Network Working Group
Internet-Draft
Updates: RFC [3032](#), [RFC 3270](#), RFC
[5129](#), [RFC 3272](#), [RFC 3443](#), RFC
3469, [RFC 3564](#), [RFC 3985](#), RFC
4182, [RFC 4364](#), [RFC 4379](#), RFC
4448, [RFC 4761](#) (if approved)
Intended status: Standards Track
Expires: June 8, 2009

**Multi-Protocol Label Switching (MPLS) label stack entry: "EXP" field
renamed to "Traffic Class" field
draft-ietf-mpls-cosfield-def-08.txt**

Figure 1

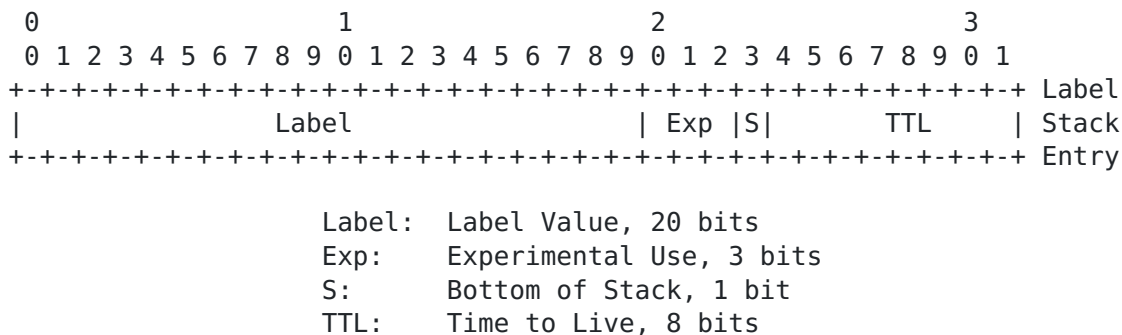
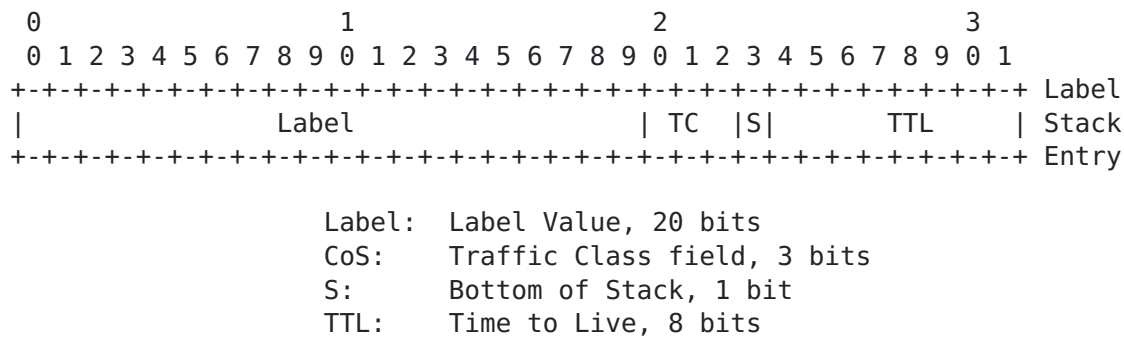
In Figure 1 on page 3 in [RFC3032](#) the format of a label stack entry is specified as:

Figure 1 in [RFC 3032](#) is now changed to match the change of name of the TC field to:

Figure 1 (new)

Note: The designation of the picture above as "Figure 1 new" is introduced as a way to distinguish the figures in this draft. It will still be "Figure 1." in [RFC 3032](#).
